**From:** Oswald, Hank  
**Sent:** Wednesday, October 27, 2021 11:35 AM  
**To:** Tony Fertitta (tonyf@fcc-eng.com)  
**Subject:** OSDS Plan\_5016 Ten Oaks Road

The OSDS Plan for 5016 Ten Oaks Road, Lot 6 has been reviewed with the following comments:

**SEPTIC SYSTEM  
 INSTALLATION SITE PLAN  
 TEN OAKS FARM, LOT 6  
 5016 TEN OAKS ROAD**

**SEPTIC SYSTEM  
 INSTALLATION SITE PLAN  
 TEN OAKS FARM, LOT 6  
 5016 TEN OAKS ROAD**

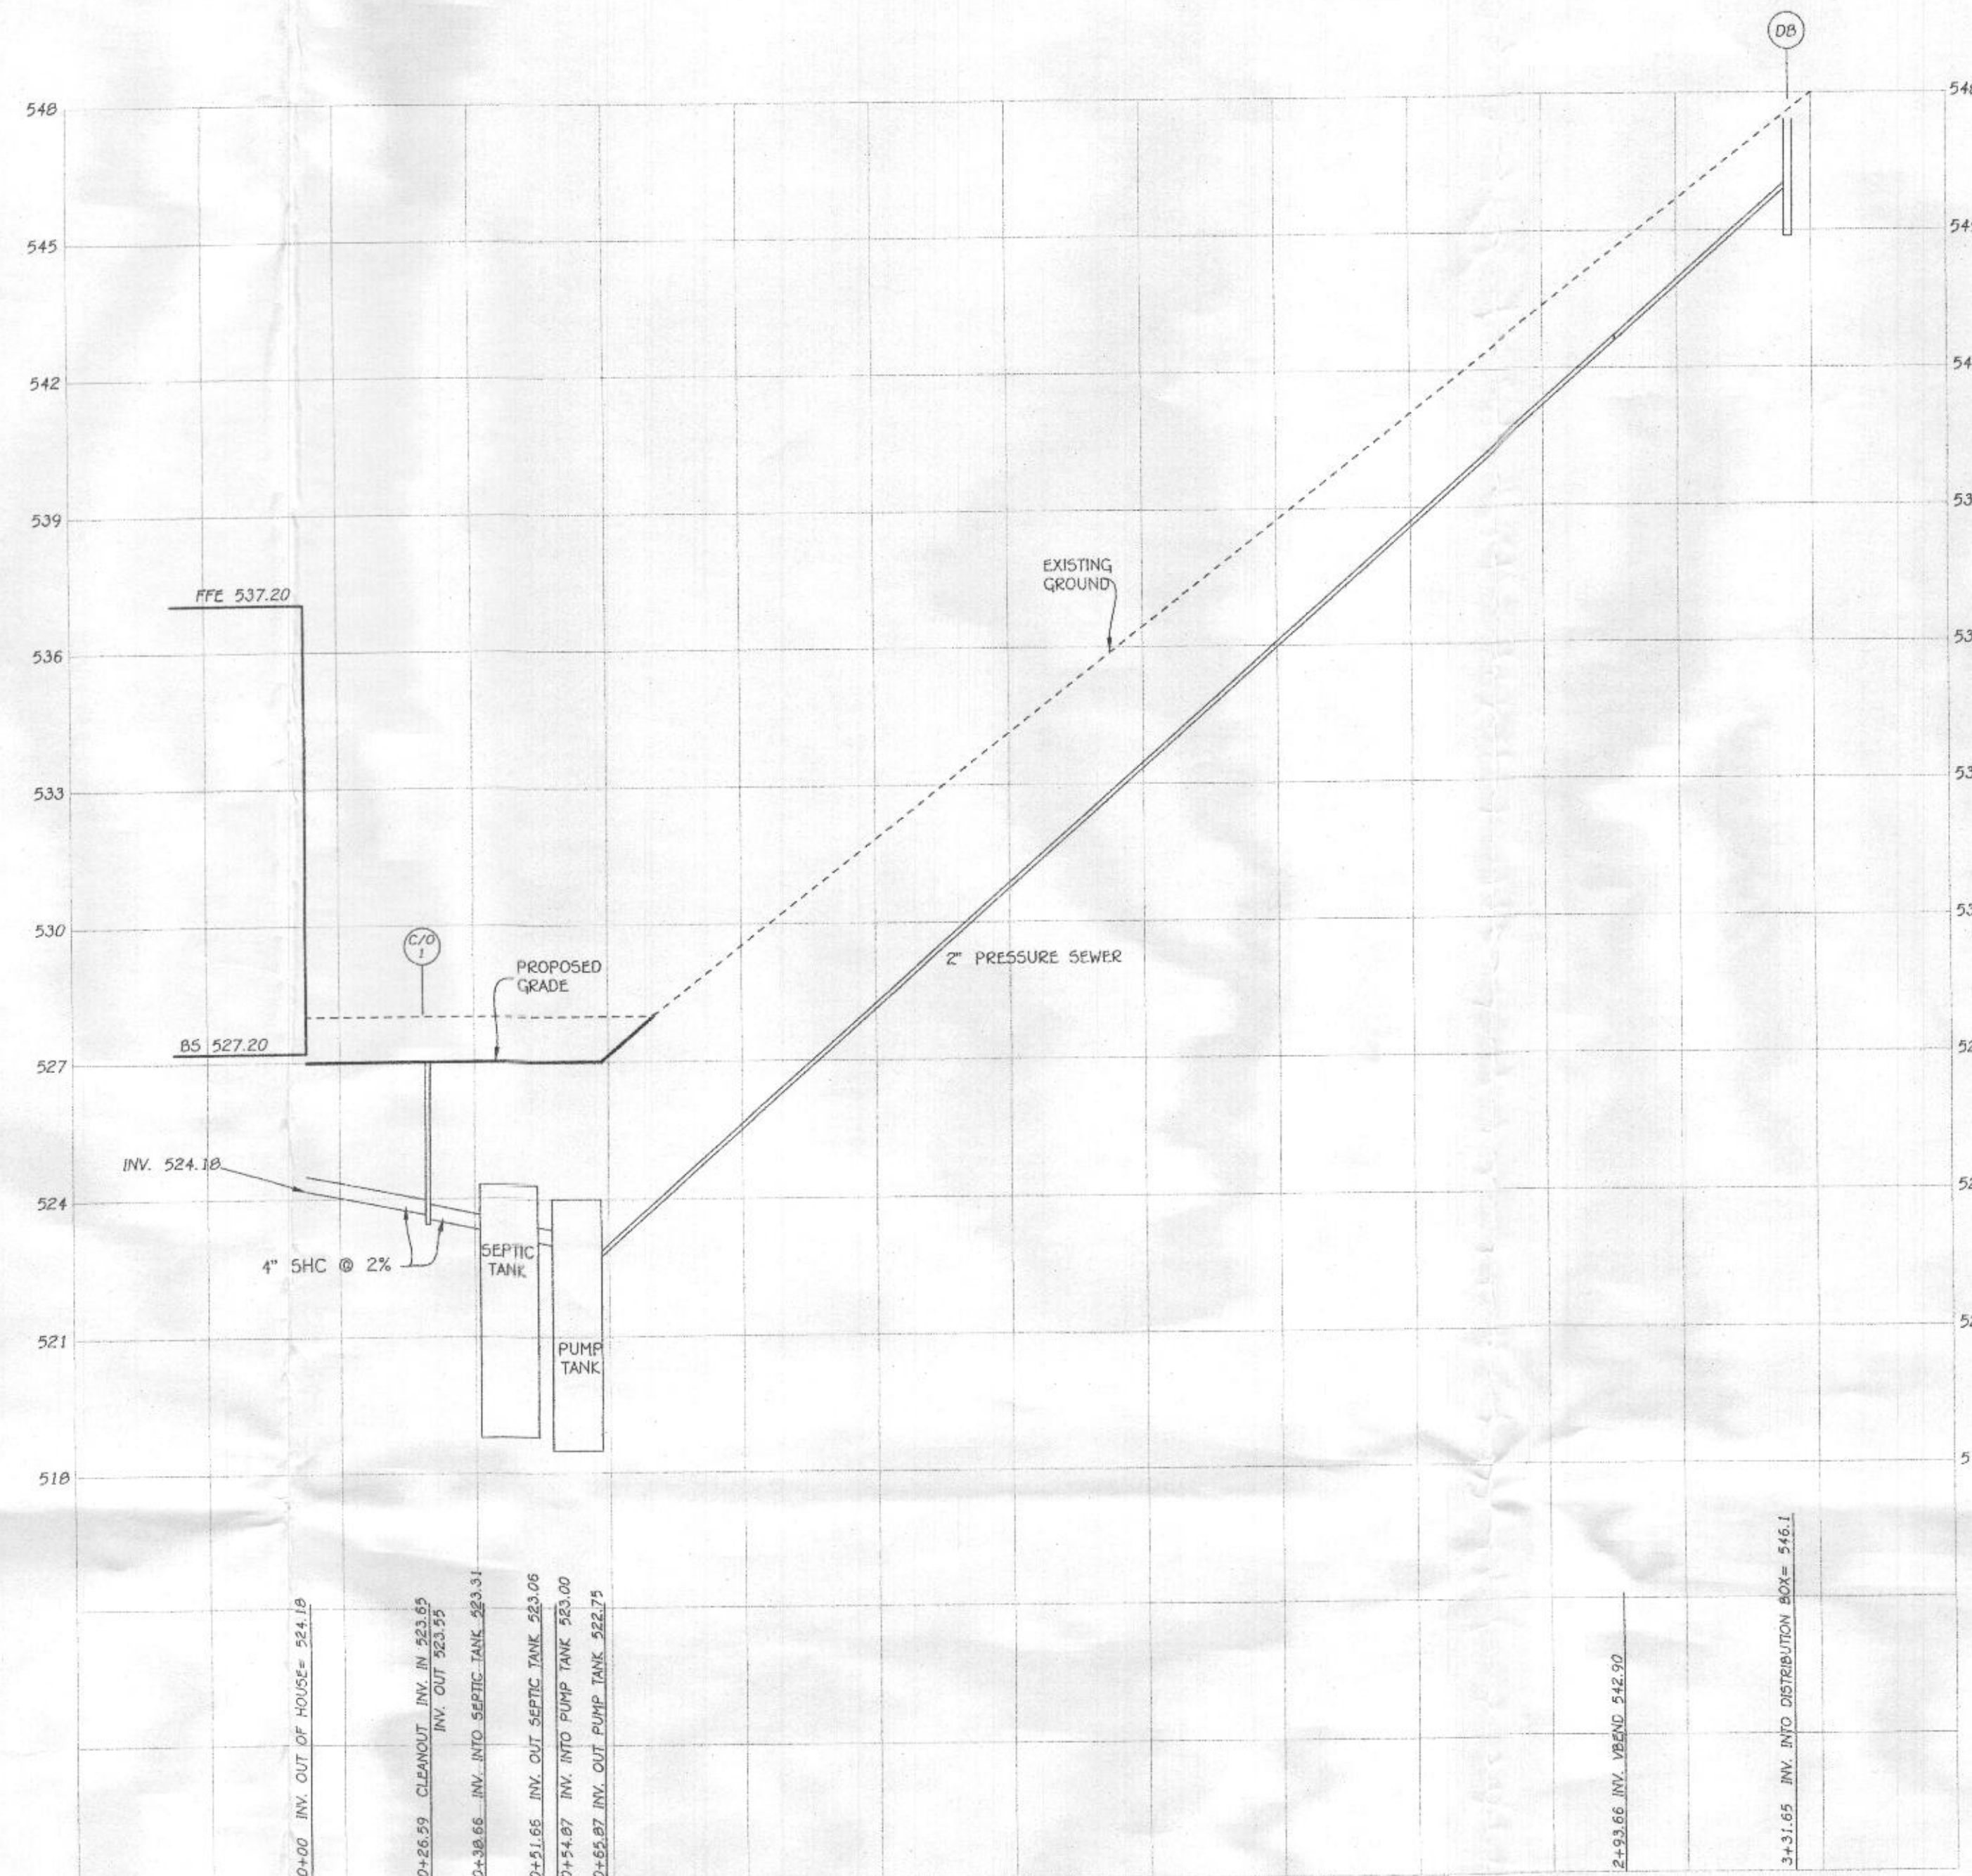
It's not ideal to run the line through the SDA. You are showing a d-box at 3' with trenches at 3', meaning the FM will be at the depth of the trenches. The FM trench running through an d potentially interfering with future trenches is not the best solution. For one thing, the trenches and d-box should be set more shallow at 2' to maximize oxygen exchange, but that doesn't solve the FM issue. I don't see why it can't run right at the side of the SDA by holes 612 and 613 to the top without being too close to the lot line and leave plenty of room for any future tree plantings.

Good afternoon Jeff, I was told to ask you about the force main being run like I have it on the plan. It has been done in the past with out any problems. Our concern is if the property owners decide to landscape along the property line by adding trees the force main would be under it. There is a use-in-common drive on the back side of the property. Attached I added a approved install that was done earlier in the year.

- 1.) Run force main around SDA to avoid damaging it during future repairs.  
We have run them up the middle in the past. Attached is one that was approved on 2-26-21

1. ANY CHANGE TO THE LOCATIONS OR DEPTHS TO ANY COMPONENTS MUST BE APPROVED BY THE ENGINEER AND THE HOWARD COUNTY HEALTH DEPARTMENT PRIOR TO INSTALLATION. A REVISED SITE PLAN MAY BE REQUIRED.
2. THE MAXIMUM EARTH COVER OVER THE TANK IS 3 FEET. GREATER EARTH COVER WILL REQUIRE A HEAVY LOAD BEARING TANK.
3. ELECTRICAL WORK FOR THE INSTALLATION MUST BE PERFORMED BY A LICENSED ELECTRICIAN.
4. THE WELL HO-15-0316 HAS BEEN FIELD LOCATED AND IS ACCURATELY SHOWN.
5. ALL WELLS AND SEPTIC SYSTEMS LOCATED WITHIN 100' OF THE PROPERTY BOUNDARIES AND 200' DOWN GRADIENT OF ANY WELLS AND/OR SEPTIC SYSTEMS HAVE BEEN SHOWN.
6. THE FORCEMAIN LINE NEEDS TO HAVE MARKING TAPE IN SECTION INSIDE THE SDA

### SEPTIC PROFILE

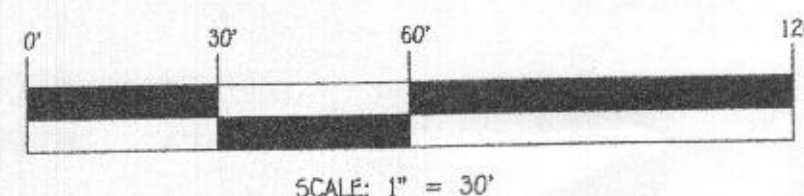
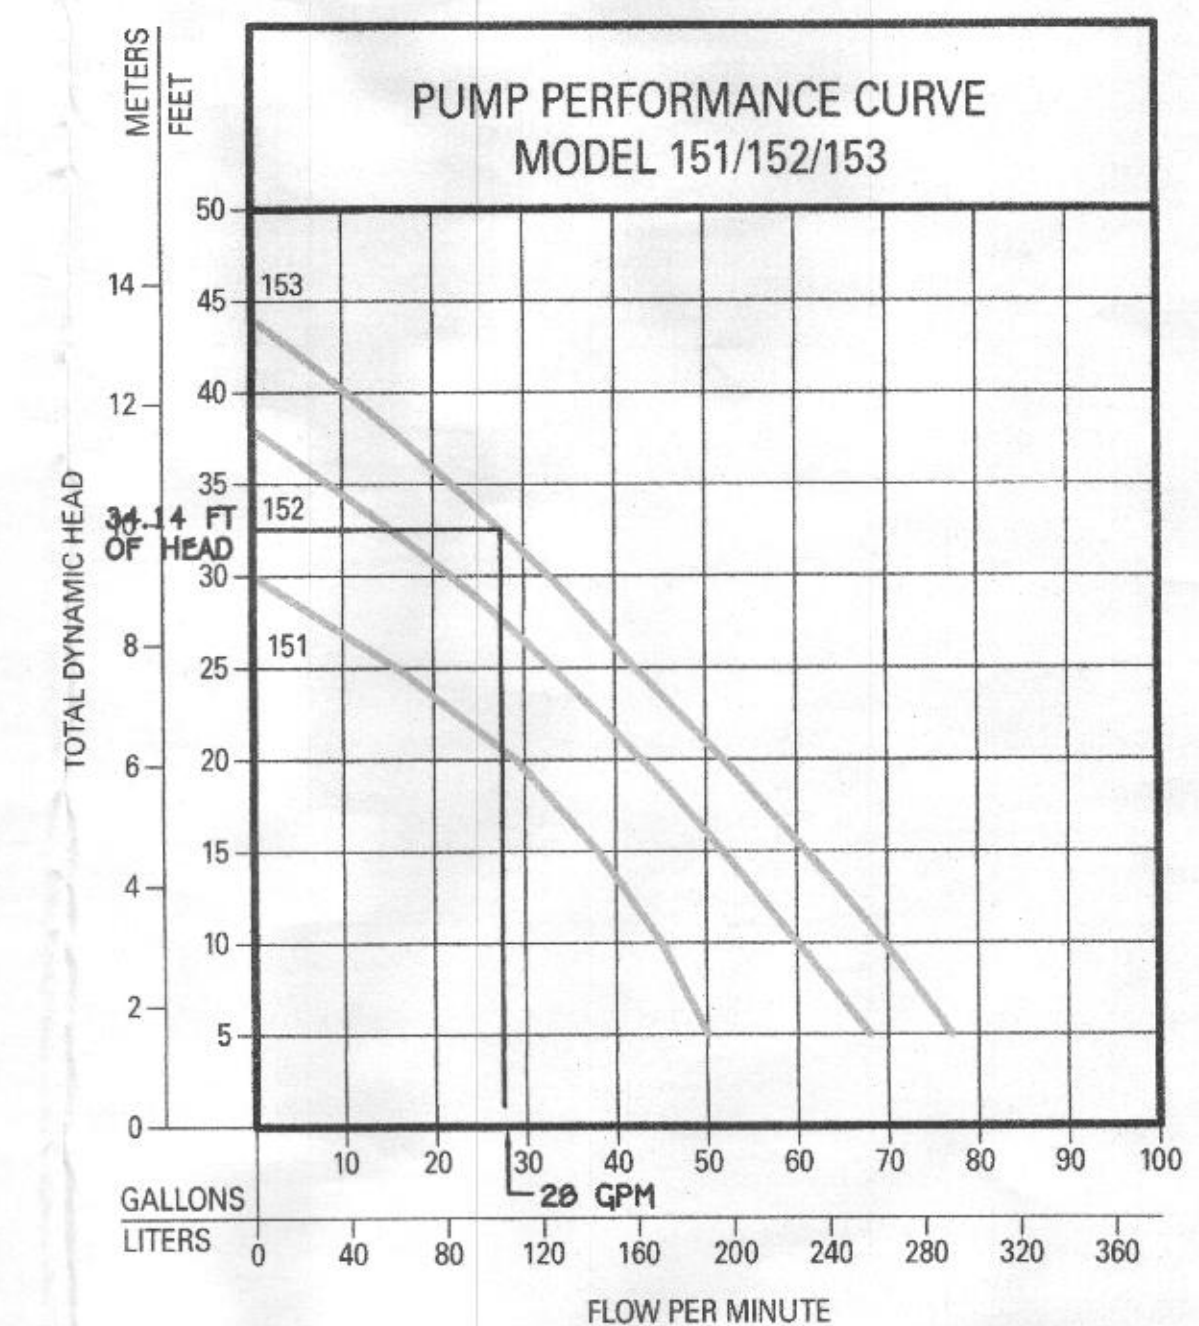
- 1.) Label existing grade and proposed grade on septic profile
- 2.) Relocate stormwater line over septic tank.
- 3.) Run force main around SDA to avoid damaging it during future repairs.
- 4.) Show 18 inch stormwater pipe in septic profile
- 5.) Trench spacing d=5 ft. for initial and first replacement system calculation.
- 6.) Show emergency storage calculation. Show how you arrived at the #s below the tank on 2<sup>nd</sup> page.
- 7.) Add existing ground elevation above d-box
- 8.) *Trench detail* has both 5.5 ft. and 4.5 ft. alongside it. It should be just 4.5 feet below trench invert.
- 9.) 150 gallon dose is the minimum. What is 125 gallon minimum shown on plan?
- 10.) Does the 0.5 HP pump require a 220v? If so, is there a pump that would work on a 120v?

- 1.) Label existing grade and proposed grade on septic profile
- 2.) Relocate stormwater line over septic tank.
- 3.) Run force main around SDA to avoid damaging it during future repairs.
- 4.) Show 18 inch stormwater pipe in septic profile
- 5.) Trench spacing d=5 ft. for initial and first replacement system calculation.
- 6.) Show emergency storage calculation. Show how you arrived at the #s below the tank on 2<sup>nd</sup> page.
- 7.) Add existing ground elevation above d-box

- 8.) *Trench detail* has both 5.5 ft. and 4.5 ft. alongside it. It should be just 4.5 feet below trench invert.
- 9.) 150 gallon dose is the minimum. What is 125 gallon minimum shown on plan?
- 10.) Does the 0.5 HP pump require a 220v? If so, is there a pump that would work on a 120v?
